Application of Champlain Hudson Power Express, Inc. for a Certificate of Environmental Compatibility and Public Need Pursuant to Article VII of the PSL for the Construction, Operation and Maintenance of a High Voltage Direct Current Circuit from the Canadian Border to New York City.

Case No. 10-T-0139

**APPLICATION OF CHPE LLC AND CHPE PROPERTIES, INC. FOR AN
AMENDMENT TO CERTIFICATE OF ENVIRONMENTAL COMPATIBILITY AND
PUBLIC NEED**

MAGNETIC FIELD CALCULATIONS FOR CHAMPLAIN HUDSON POWER EXPRESS TRANSMISSION PROJECT: COMPARISONS OF 1,000 MW AND 1,250 MW DC CABLE CONFIGURATIONS IN WATER BODIES

REVISED TYPICAL TRENCH DETAIL FOR HVAC CONFIGURATION

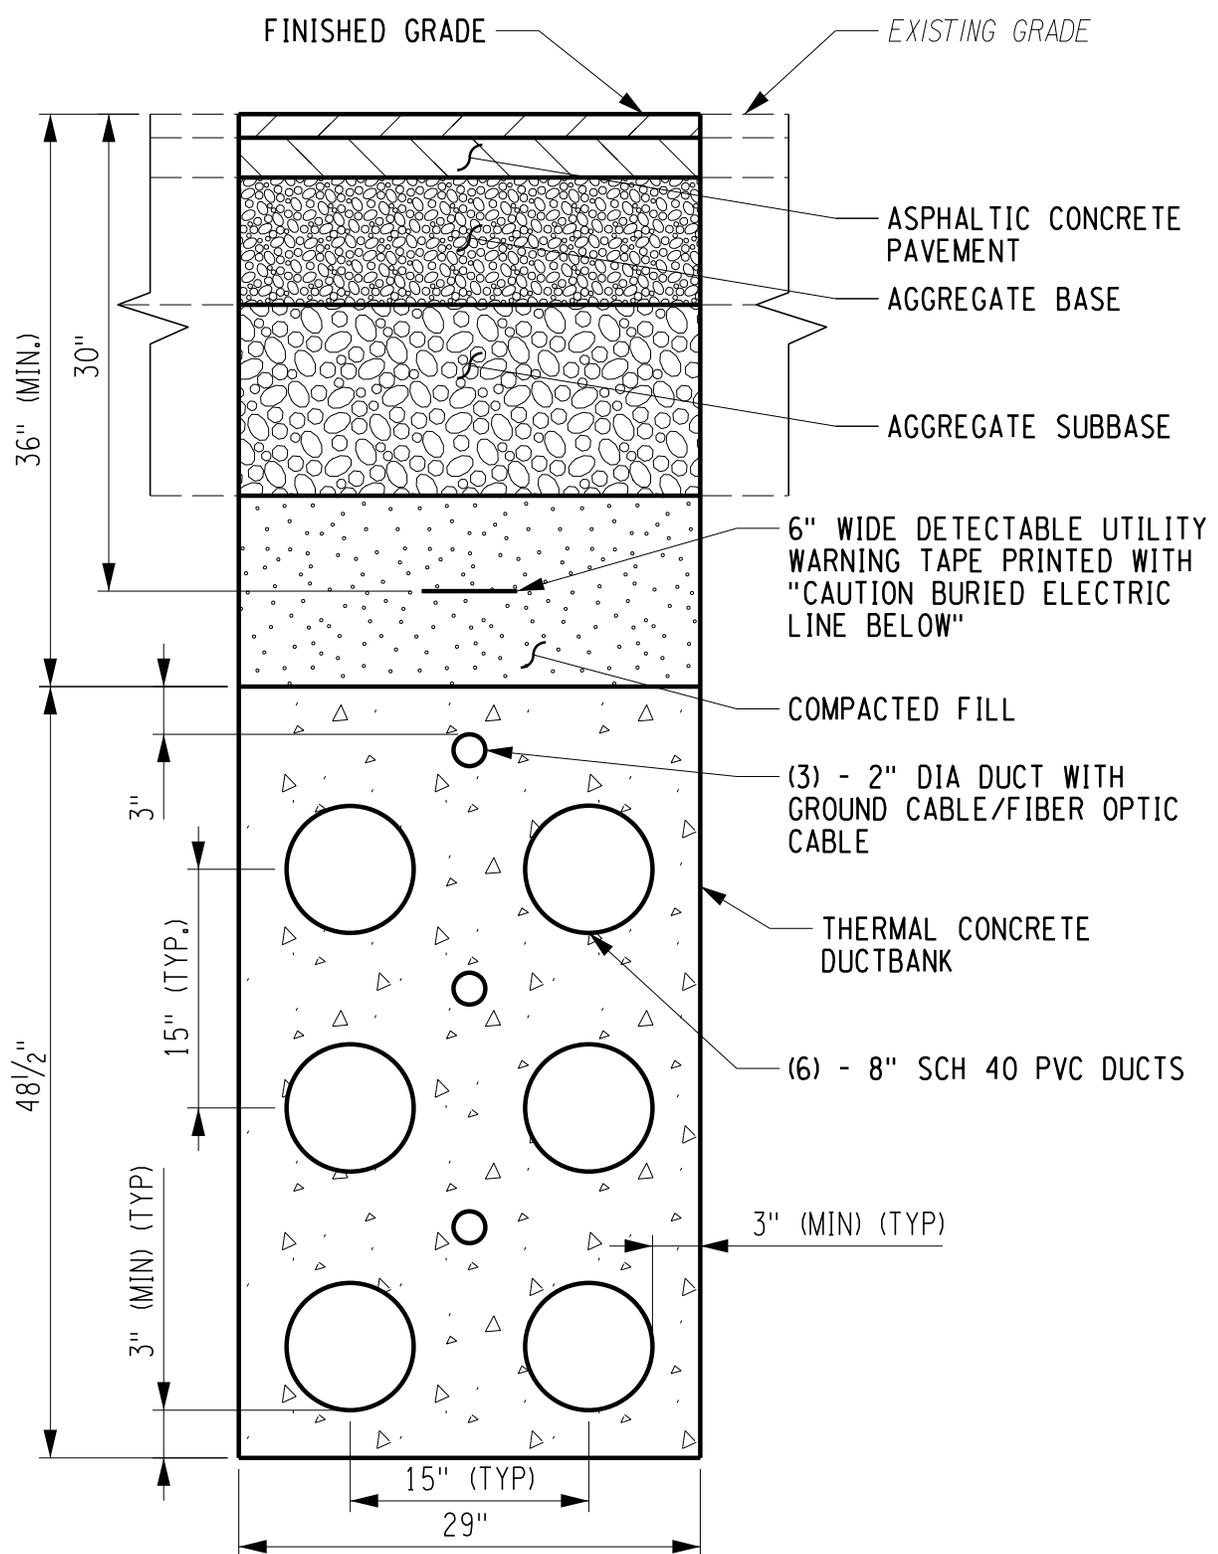
19. In the Project Documentation, HVAC cables are shown extending from the Astoria East substation to the Rainey substation. These cables will be installed via techniques that remain unchanged from those described in the Project Documentation. To accommodate the 250 MW uprate, the design of this HVAC system has been altered such that there are now two conductors per phase proposed instead of one conductor per phase. The two conductors per phase system uses smaller diameter cables, which results in a narrower, but deeper configuration compared to the one cable per phase system. A typical diagram showing the new HVAC configurations is included as Exhibit A.
